TECHNICAL BULLETIN

Rattle After Start – Upper Timing Chain – Install Revised Tensioner

12-61

MODEL All AJ6

ILLUSTRATION 1

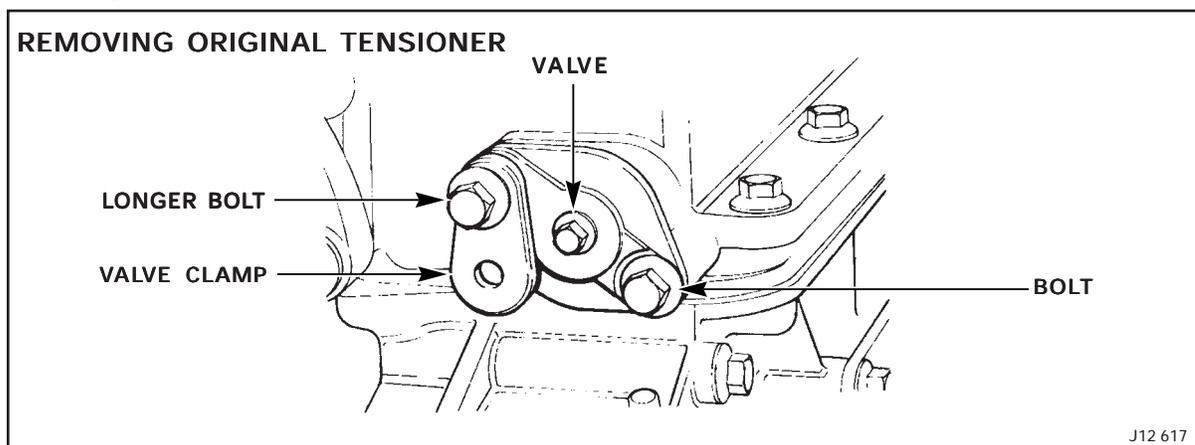
1. Remove the fuel pump relay and run the engine at idle to depressurize the fuel system.
2. Remove the longer bolt (Illustration 1), remove the valve clamp and remove the valve.

NOTE: The longer bolt and the valve clamp can be discarded since they are not required with the revised tensioner.

ILLUSTRATION 2

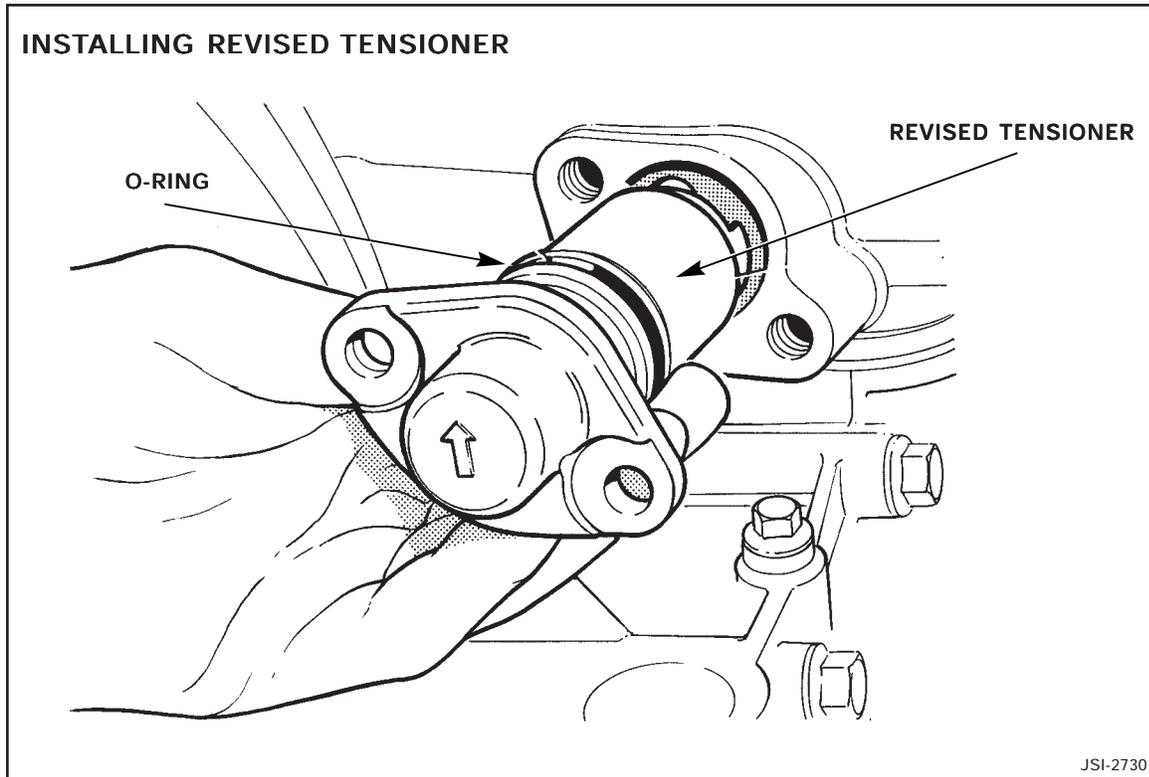
A revised tensioner with an integral oil reservoir has been introduced to overcome this condition starting with the following engine numbers:

5. Place the O-ring on the revised tensioner (Illustration 2) and lubricate it with engine oil.
6. Check that the mechanical tensioner within the piston is fully retracted (fully closed position.)
7. Install the tensioner assembly with a new gasket on the engine. Ensure that the arrow is pointing up and that the slotted head of the piston is aligned with the tensioner blade. (The bolt listed in the part information replaces the longer bolt previously discarded.) Torque the bolts to 16.2 - 20.7 lb. ft. (22 - 28 Nm.)
